Wisconsin Department of Transportation

Proposal #03: 1070-00-71, WISC 2016 045
La Crosse – Sparta
Safety Rest Area No. 31
IH 90
La Crosse County

This is Addendum No. 01, which provides for the following:

ADDENDUM NO. 01

Addendum No. 01
ID 1070-00-71
Revised Sheet 22
March 2, 2016

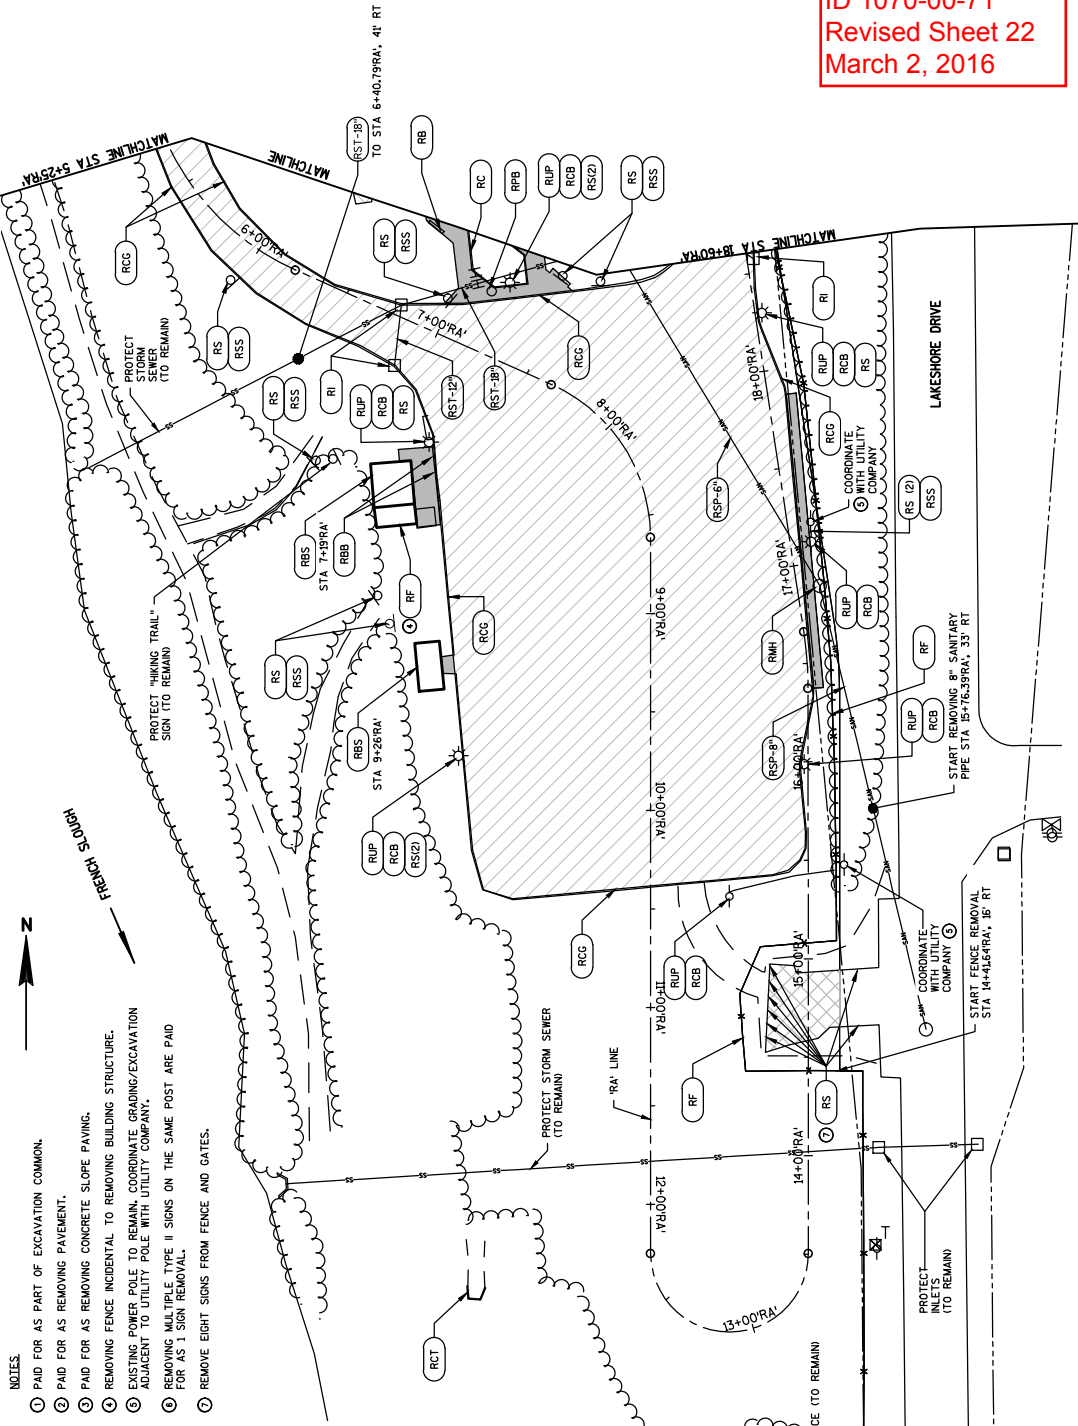
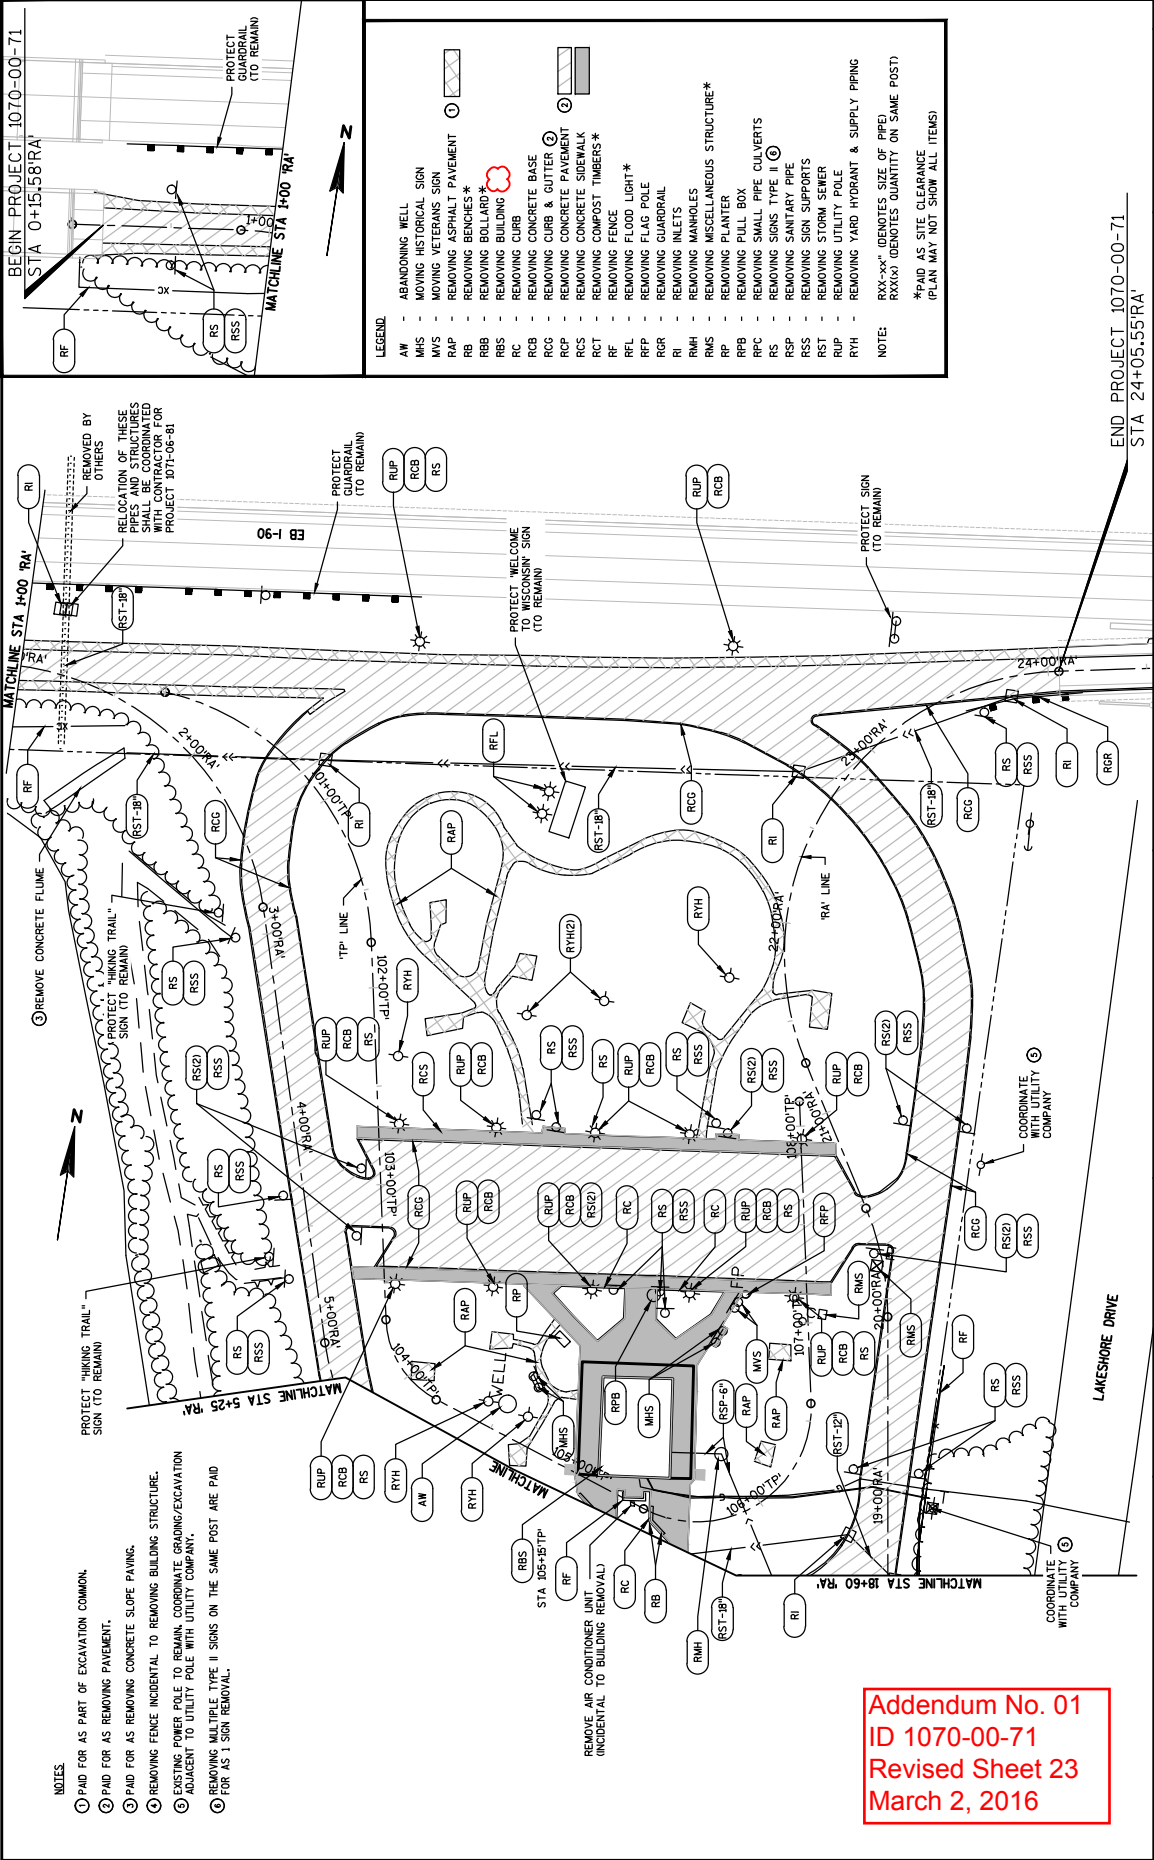
Revised Plan Sheets	
Plan Sheet	Plan Sheet Title (brief description of changes to sheet)
16	Construction Details – Overhead Sign Support (deleted concrete masonry and steel reinforcement items from Total Estimated Quantities)
22	Removal Details (deleted asterisk (*) associated with the item “Removing Building” in sheet Legend)
23	Removal Details (deleted asterisk (*) associated with the item “Removing Building” in sheet Legend)
34	Pavement Grade and Joint Layout (revised pavement joint locations, dimensions)
130	Miscellaneous Quantities (added tabulation for Item “Removing Building (Station)”, added Item 203.0210.S – Abatement of Asbestos Containing Material to Project Items tabulation)
